UNITED STATES PATENT AND TRADEMARK OFFICE

| APPLICATION NO. | FILING DATE | FIRST NAMED INVENTOR | ATTORNEY DOCKET NO. | CONFIRMATION NO. |
|-----------------|-------------|----------------------|---------------------|------------------|
| 10/733,539 | 12/11/2003 | Timothy A. Tamsin | 20030317.ORI | 2641 |

Office Action Summary

DETAILED ACTION

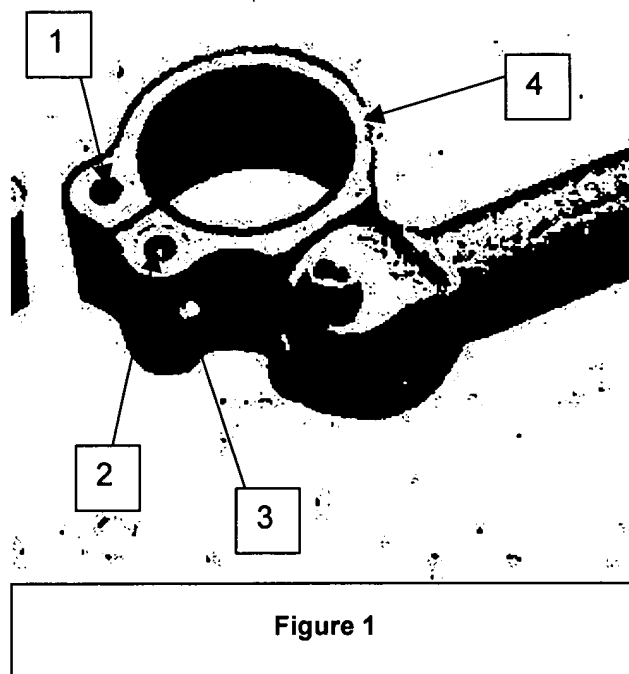
Twobros (see Figure 1 in this action) teaches a split ring clamping arrangement in which a locking portion integral with the split ring has a first post aperture (2) and a second post aperture (1), one on either side of a gap in the split ring, and a bolt aperture (shown by the positioning of bolt 3) through the locking portions, a first post having a smooth wall aperture there through and a second post having an aperture with a threaded wall there through (this is clearly true from the illustration), and a bolt (3) for extending through the locking portion apertures and the posts for engaging the threads of the second post to adjust the size of gap between the locking portions. This arrangement is taught as useful to distribute the clamping load over the entire split ring. Accordingly it would have been obvious to one of ordinary skill in the adjustable handle bar clamp art at the time of applicant's invention, to modify an arrangement as disclosed by Kobacker to include a clamping arrangement as taught by twobros for the purpose of evenly distributing the clamping load.
